# PARTS & SERVICE NEWS

REF NO.	AT03124
DATE	Jul. 4, 2003

**SUBJECT:** REPAIR PROCEDURE FOR BODY HEATING EXHAUST PIPE ON HM300-1

**PURPOSE:** To introduce modification procedure to repair the body heating exhaust pipe on HM300-1 articulated dump trucks

3. Details of the modification

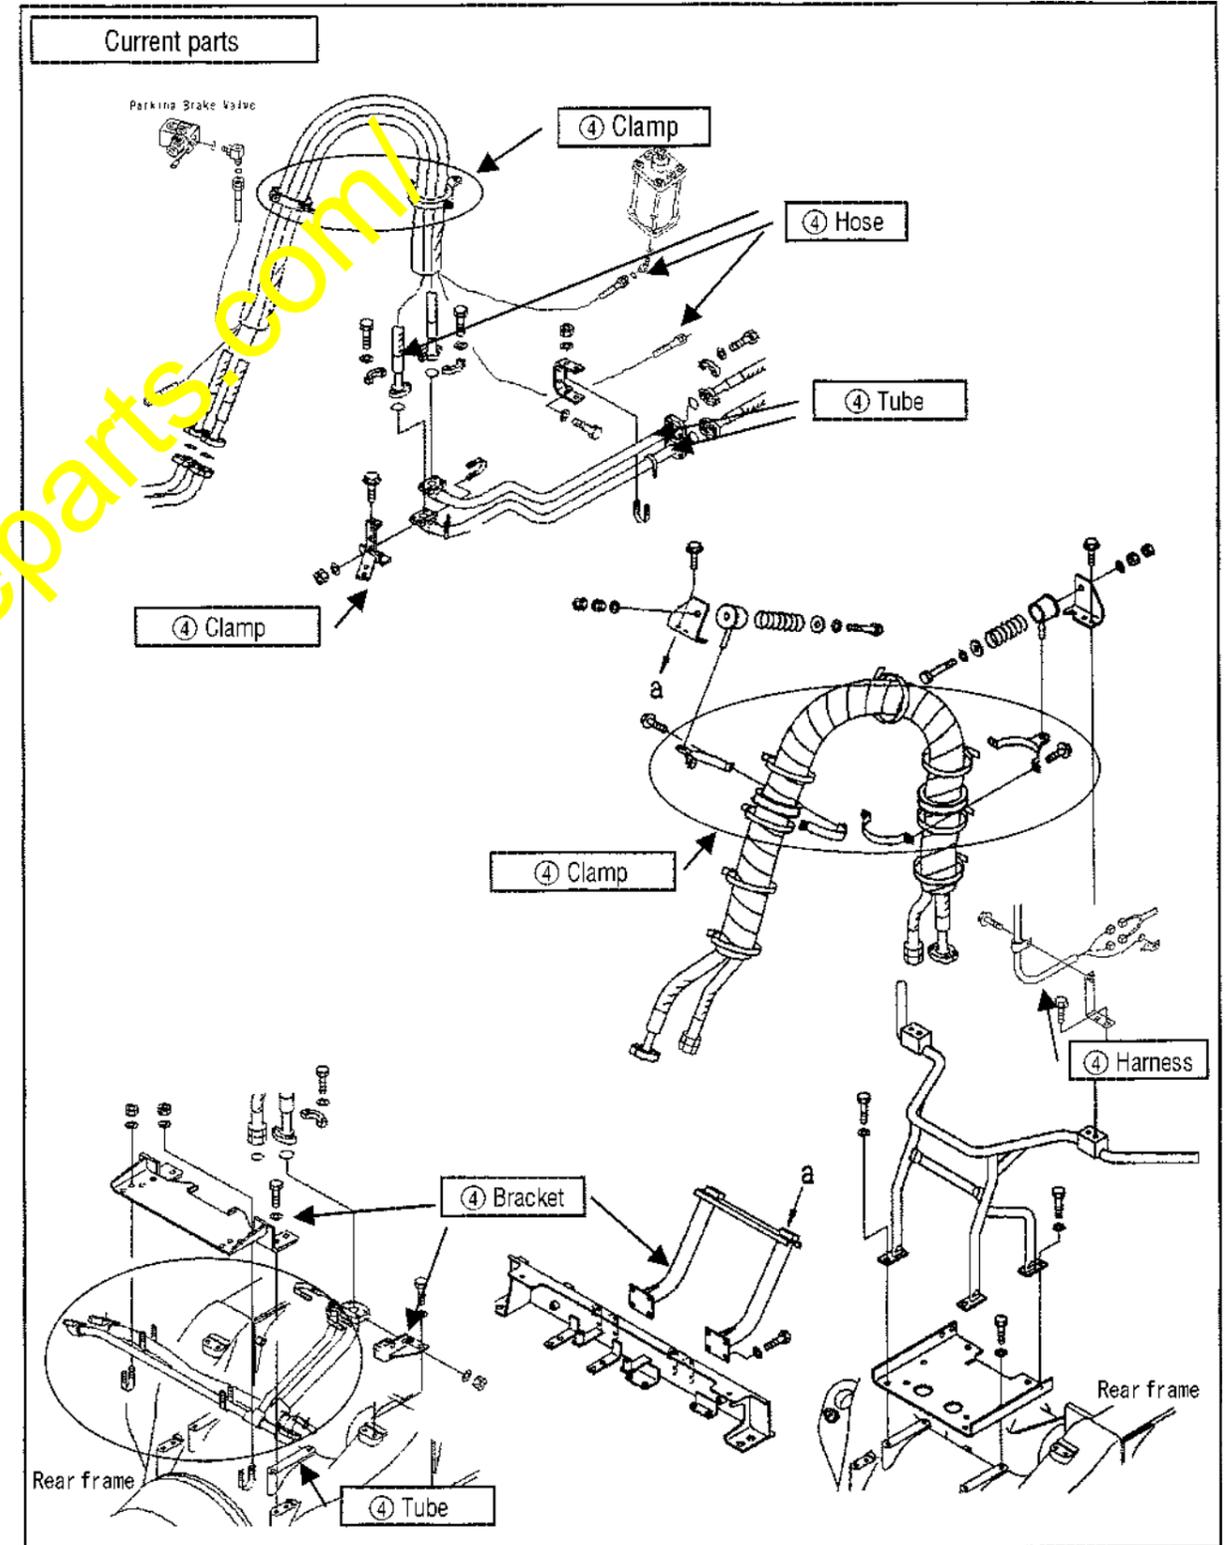
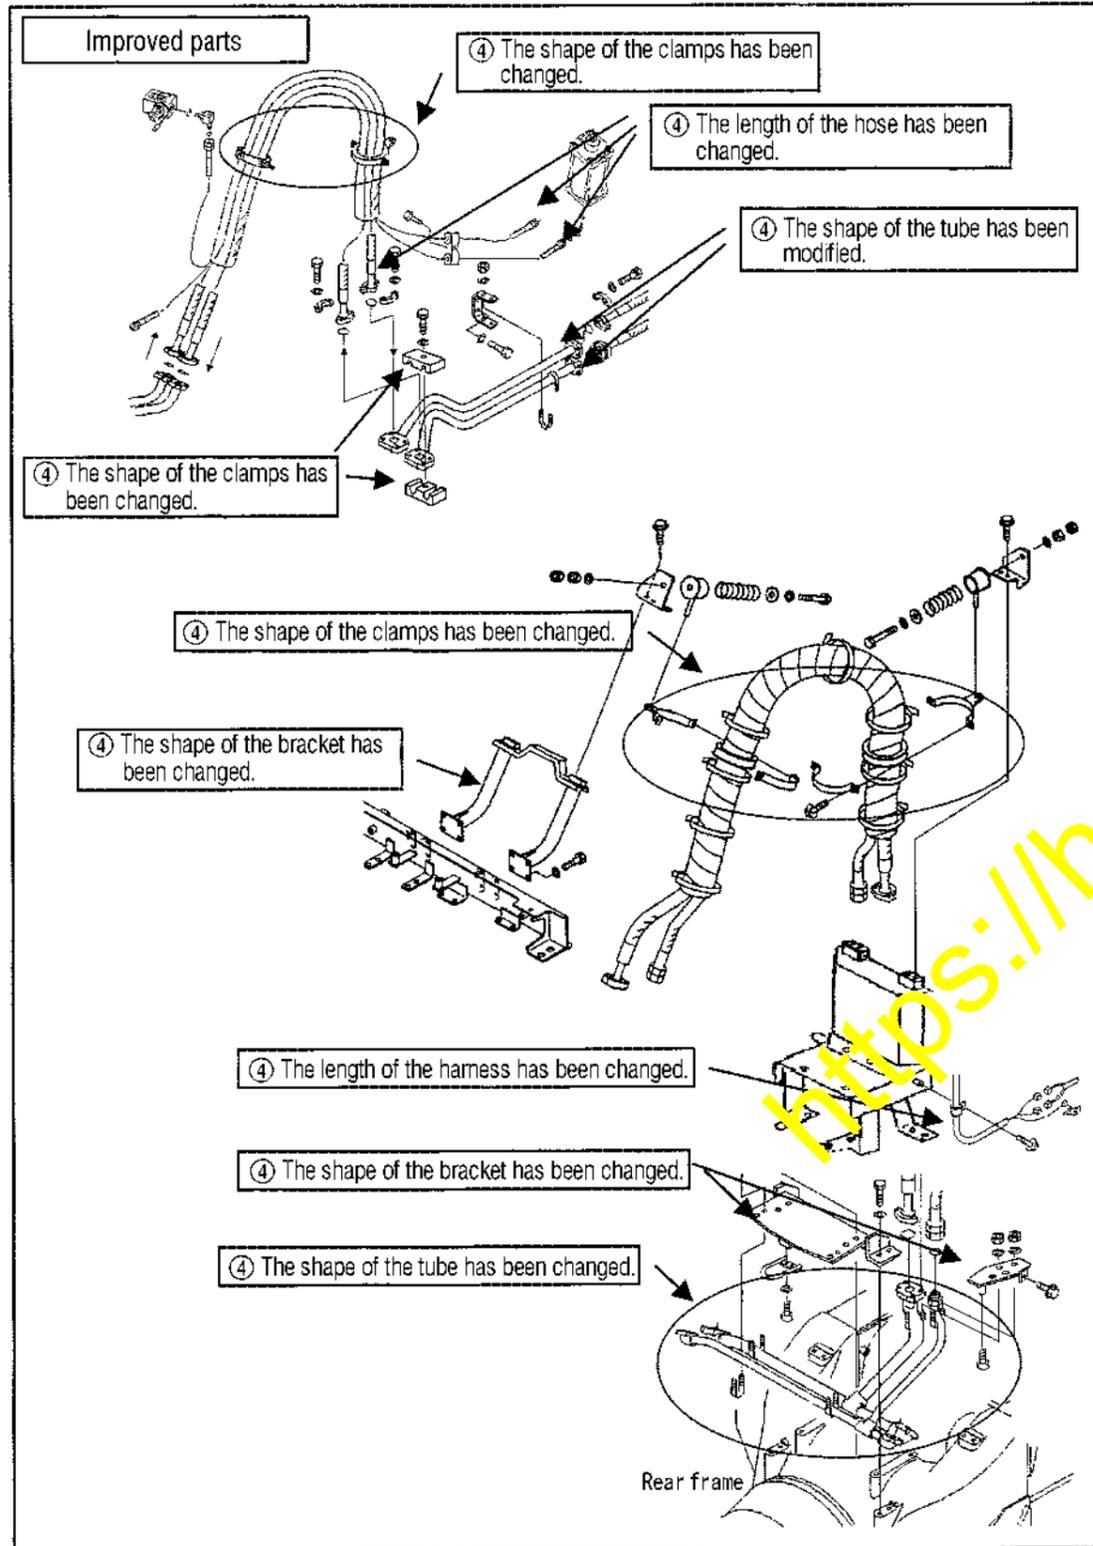
- ① Modification to prevent occurrence of rotation of the bellows of the exhaust pipe  
The shape of the turning lock and the shape of the stopper for the rear side spherical joint have been modified to restrict occurrence of rotation of the bellows.
- ② Modification to prevent occurrence of twisting of the bellows of the exhaust pipe  
Moving the position of the exhaust gas shutter, the length of the bellows have been increased to prevent occurrence of twisting.  
(Pursuant to this modification, the length of the tube connecting between the exhaust gas shutter and the body has been changed and the shape of the heat shielding cover has been modified.)

- ③ Modification to prevent occurrence of interference of the hydraulic hose  
The shape and positions of the clamps for the hydraulic hose in the neighborhood of the bellows have been changed to prevent occurrence of interference.  
Also, the shape of the exhaust pipe and the shape of the cover have been changed to secure necessary clearance with the hydraulic hose.

5-1. Disassembly procedure

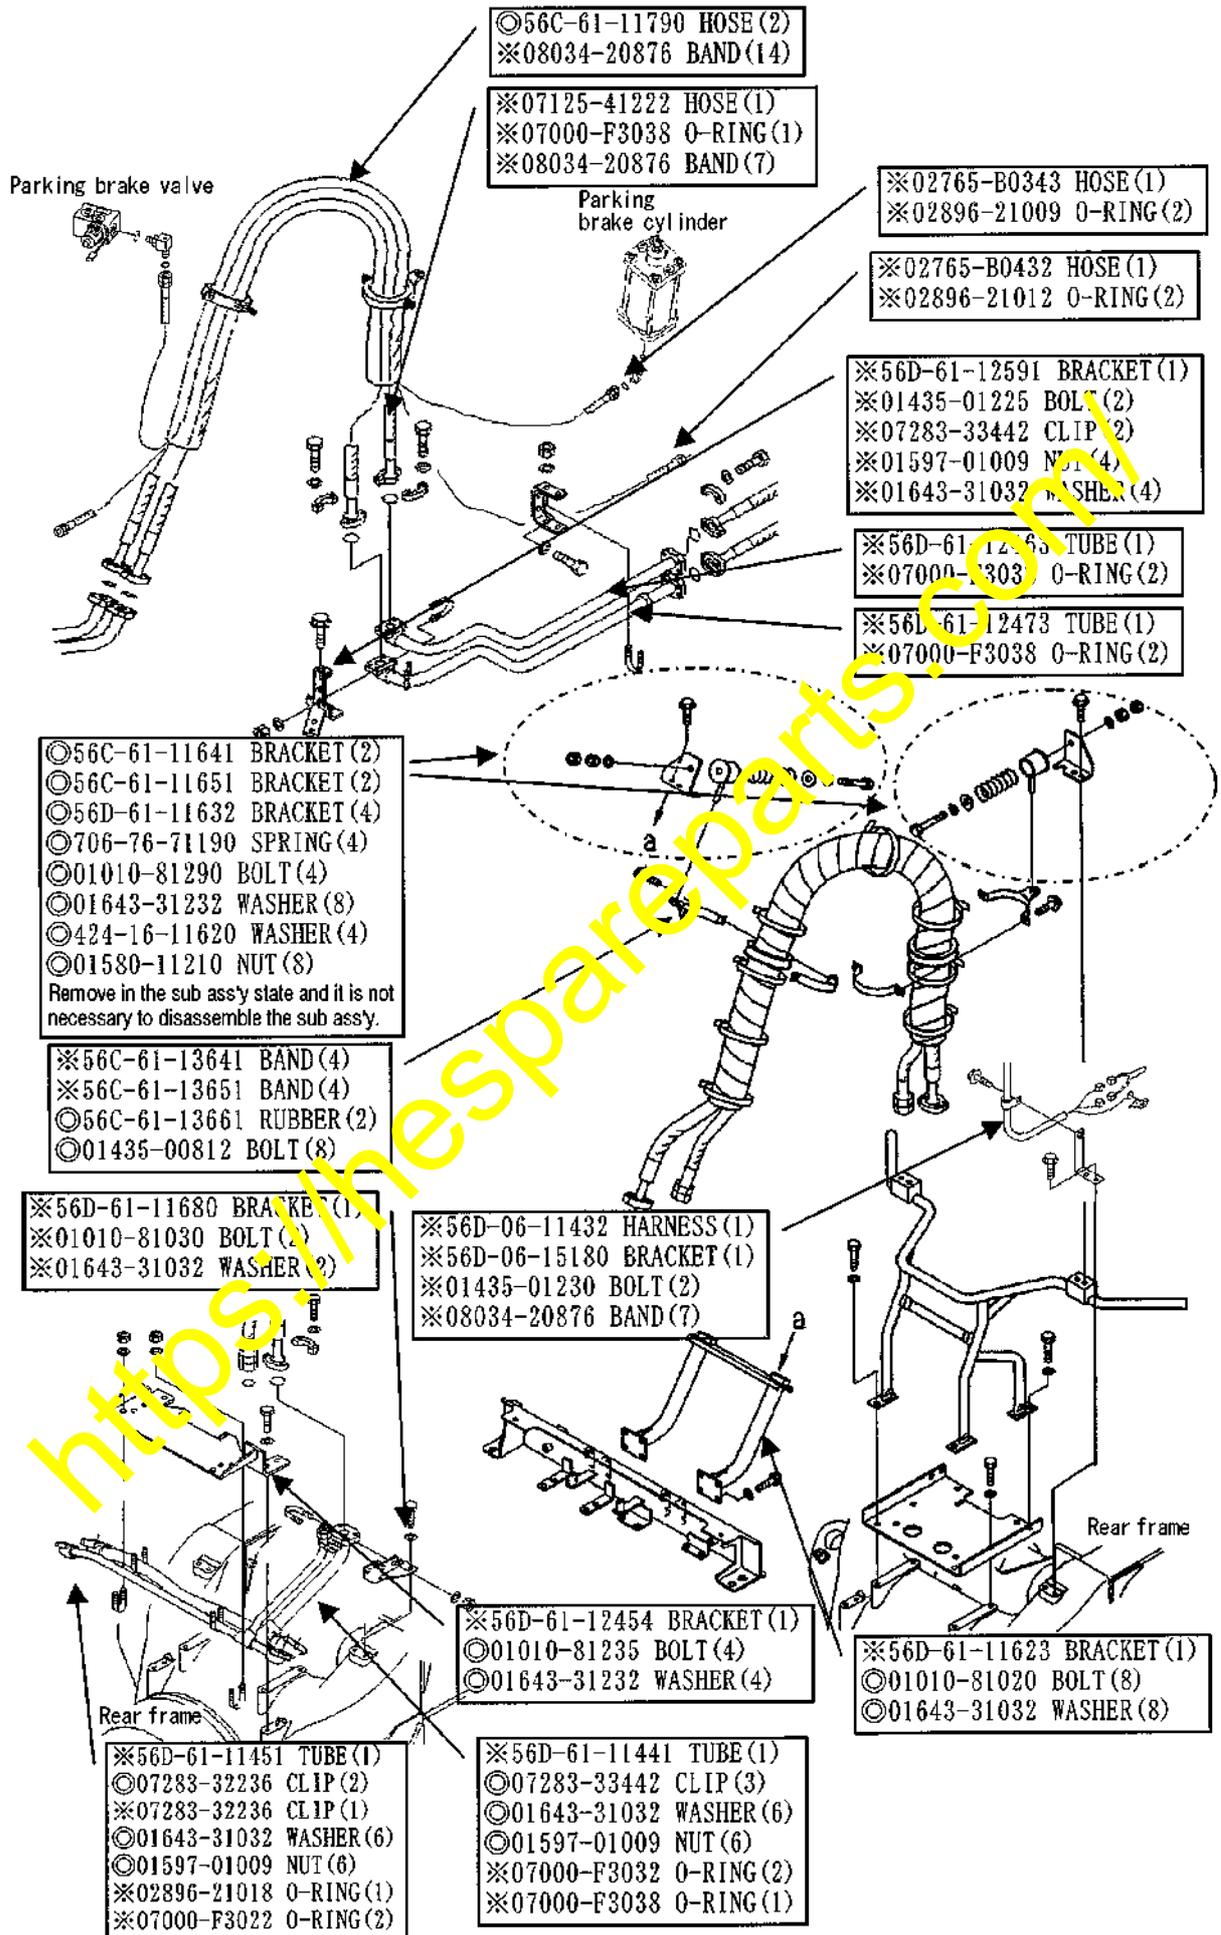
Remove the parts marked © and marked ※ in the drawing below.

Since the parts marked © are being reused when assembling the improve parts, be careful not to lose or break them.

Parts marked ※ are to be replaced.

Parts marked ☆ are to be additionally worked.

5-2. Assembly procedure

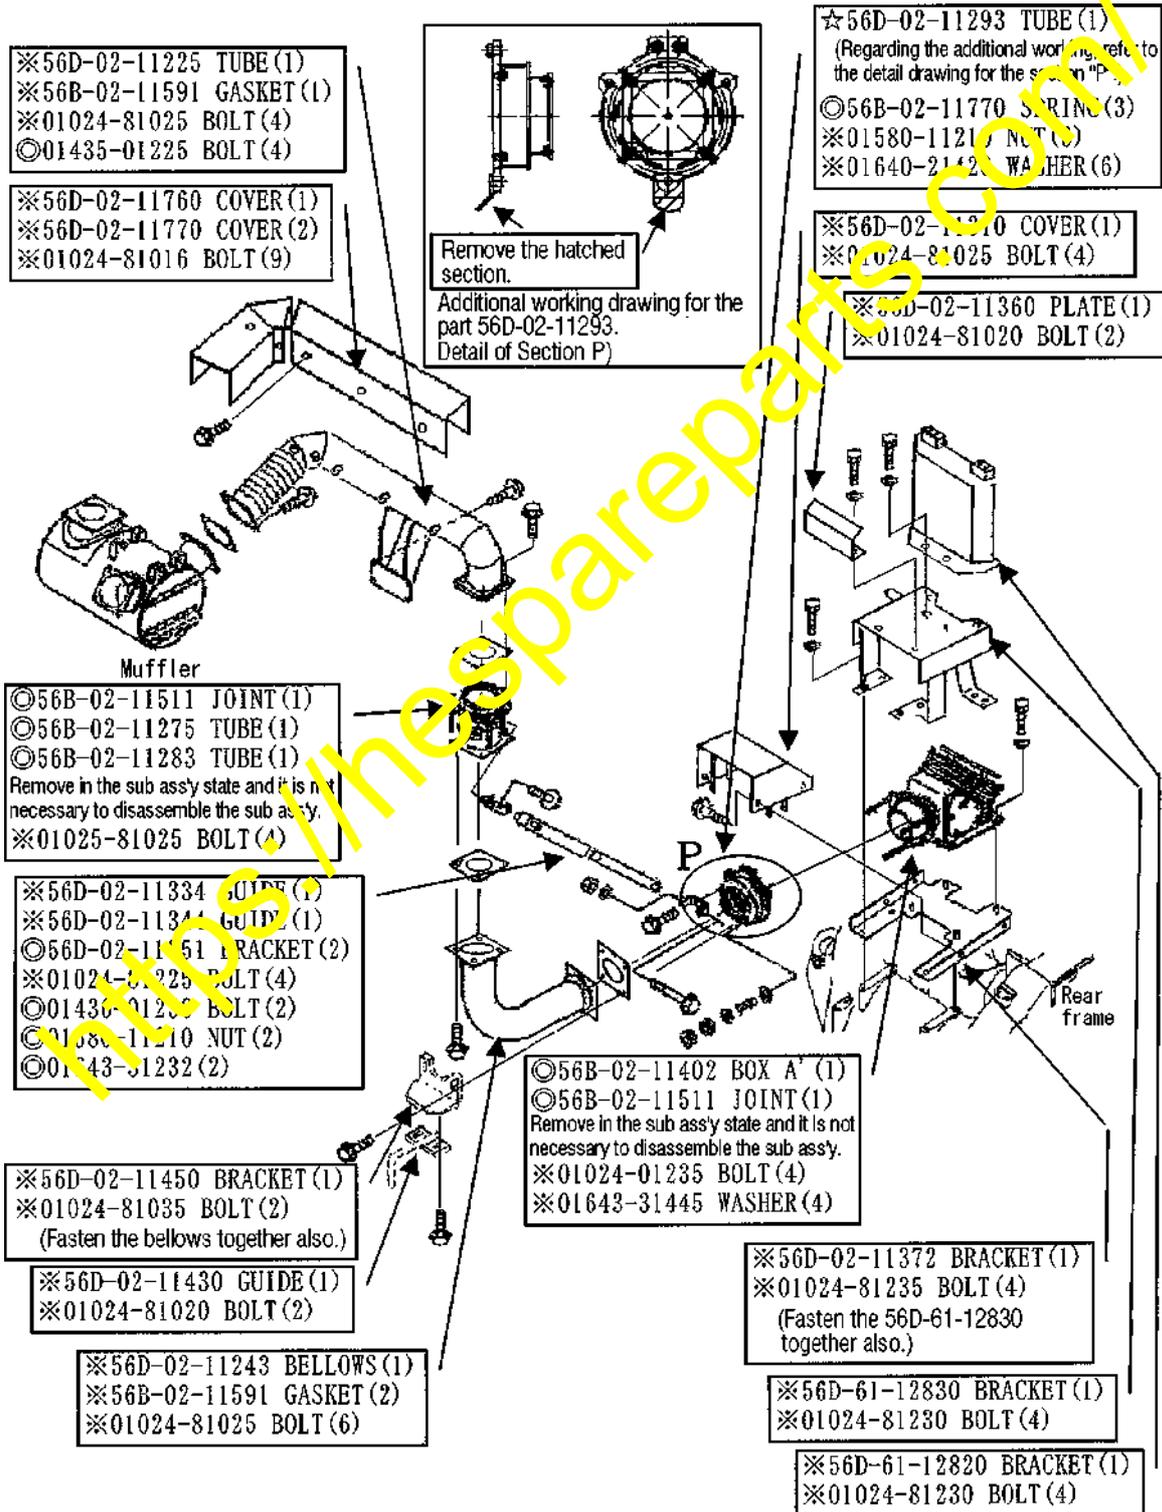
- 1) Make additional working of the tube (56D-02-11293) as per the instructions given in the additional working drawing shown below.
- 2) Install the box A' (56B-02-11402) and the cover (56D-02-11310) to the bracket (56D-02-11372), and after that, install them to the rear frame together with the brackets (56D-61-12820 and 56D-61-12830) and tube (56D-02-11293).  
The installed length of the spring (56B-02-11770) should be 60 mm. (Refer to page 9.)
- 3) Install the tube (56D-02-11225), covers (56D-02-11760 and 56D-02-11770) to the front frame.
- 4) Install the joint sub ass'y (56B-02-11511 and others) to the tube (56D-02-11225).

- 5) Install the bellows (56D-02-11243), bracket (56D-02-11450) and guide (56D-02-11430) to their respective positions between the joint sub ass'y (56B-02-11511) and the tube (56D-02-11293).  
In the meantime, install the bracket (56D-02-11450) to the tube (56D-02-11294) together with the bellows (56D-02-11243).
- 6) Install the guides (56D-02-11334 and 56D-02-11344) and bracket (56D-02-11351) to the joint sub ass'y (56B-02-11511) and tube (56D-02-11293).  
When installing the guides (56D-02-11334 and 56D-02-11344) and bracket (56D-02-11351), do not fasten them but install them so that they may turn and tighten them by use of double nuts (01580-11210).
- 7) The mounted state dimension of the spring (56B-02-11770) should be as per the instruction in the drawing shown below. (Common for the front and rear)
